Final Inspection Report
WQS Insp. # [REDACTED]_JUN25_09_FI009

Product Name: Electric Food Slicer
Product / Item Number: 8809
Quantity Ordered: 4,452 pcs total
Styles / Colors: White

Final Inspection Report

Back mark 120V/60Hz (actual)
230-240V/50Hz (Requested)

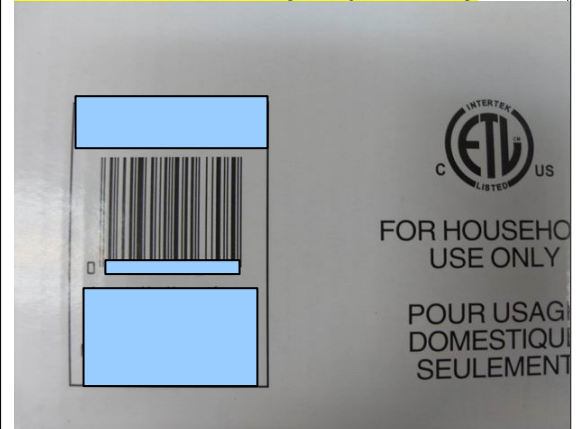
1. Factory had still producing 52pcs slicer on production line during inspection; please refer to the attached photos below,
2. Actual measure blade length 165mm is deviated with required 170mm
3. Actual AC 120V/60Hz input voltage is deviated with required 230-240V/50Hz on inspection information form from client.

Drop Test A (away 76cm)

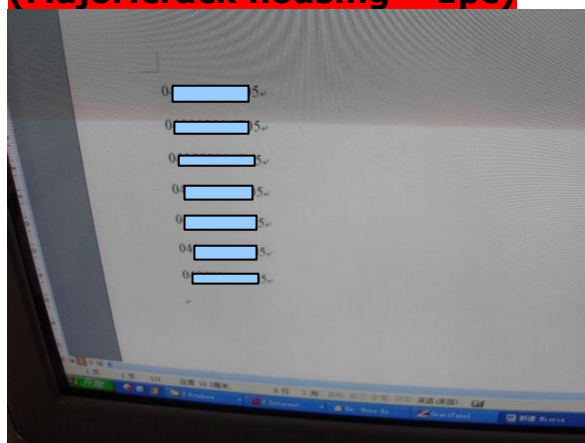
Inspection Standards: Level II, AQL Minor Defects 2.5, Major Defects 1.0
Major Defects Found = 1
Minor Defects Found = 7
Critical = Not Applicable
Additional Remarks: Crack on housing after carton drop away 76cm

Drop Test Resulted in one cracked housing (see drop test below)
